Subject: **FCC Class II Permission Change Request for FCC ID: N82-KOHLER053**

This is to request a Class II Permission Change Request for FCC ID: N82-KOHLER053, originally granted on 09/26/2023.

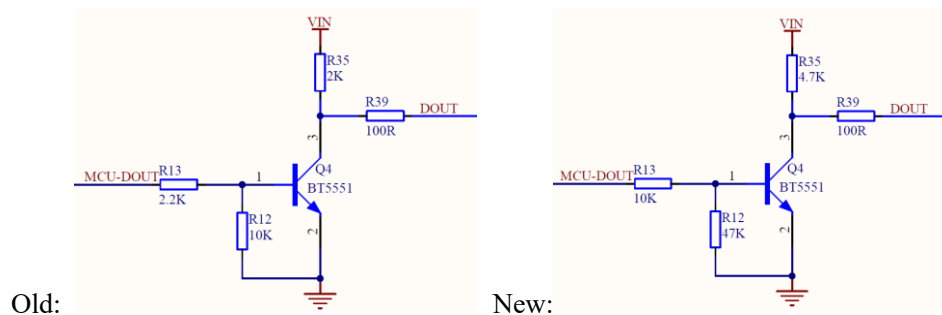
No.	Site	Component	Old	New	Comment
1	U5	LDO	RUN-IC RS3005-3.3	CHANGJING CJ6376A33MR	5V to 3.3V
2	R13	Resistor	2.2K	10K	Driving resistor of transistor base
3	R12	Resistor	10K	47K	Pull-down resistor of transistor base
4	R35	Resistor	2K	4.7K	Pull-up resistor of transistor collector

LDO

Resistor
